**BIDS AND AWARDS COMMITTEE FOR INFRASTRUCTURE PROJECTS (BAC-I)**

**Construction of New Clark City Underground Utilities Phase 1**

**BID BULLETIN NO. 02**

This Bid Bulletin contains clarifications raised during the Pre-Bid Conference held on 28 March 2025 as well as queries sent by prospective bidders via email, and other matters relating to the Project.

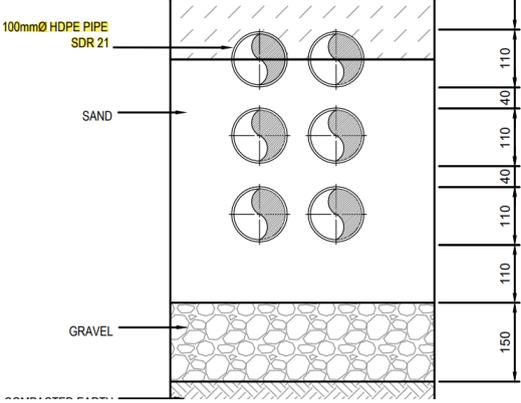
Queries/Questions	Clarifications / Responses
<b><u>CM PANCHO CONSTRUCTION, INC.</u></b>	
<p>Q1. Part J Electrical Works (Under Utility) 633(1)c5 Cable Duct thru Road, HDPE (High-Density Polyethylene) pipe, 18 Runs -100mm Ø, up to 150psi, 10mm thick (Overall OD@ 110mm) 1111(5)a1 EE 3 Way Primary Manhole with Cast-iron cover with complete accessories 1111(5)a2 EE 4 Way Primary Manhole with Cast- iron cover with complete accessories</p> <p>1. The given Bill of Quantities is for the cable duct thru road only. <u>Kindly provide the detailed drawing for duct passing thru bridges and we are requesting to provide separate pay item since the scope of works is not the same.</u></p> <p>In addition, we are requesting for</p>	<p>1. The utility bridges are not included in the scope of work of the project.</p>

<p>the detailed design of conduit for each bridge along the following location:</p> <ol style="list-style-type: none"><li>a. Waterway bridge along Green Blvd Gateway (Road 1A)</li><li>b. Bridge along Pueblo St. (Road 2B)</li><li>c. Bridge along Narra Ave. (Road 4B)</li><li>d. Bridge along Macabulos Ave. (CBC Road)</li></ol> <p>2. On Drawing No. EE-CR-24 on the issued hard copy of plans the cable duct passing thru waterways will be mounted on concrete utility bridge; whereas, on Drawing No. MSC-PBR-02 on the downloadable bidding plans on BCDA Website, the cable duct will be hanged under the sidewalk of the existing waterway bridge using cable trays. Please confirm the plan to be used.</p> <p>3. Kindly clarify also if the construction of utility bridge as specified in Drawing No. EE-CR-24 is included in our scope of works or this will be done by another contractor because we noted that in the given plan there are some locations wherein the proposed electrical duct bank with cross the waterway but there is no existing utility bridge.</p> <p>In addition, if the utility bridge is included in our scope of work, detailed structural design</p>	<p>2. The cable duct will be hung under the existing waterway bridge using a cable tray therefore, use Drawing No. MSC-PBR-02.</p> <p>3. The utility bridges are not included in the scope of work of the project.</p>
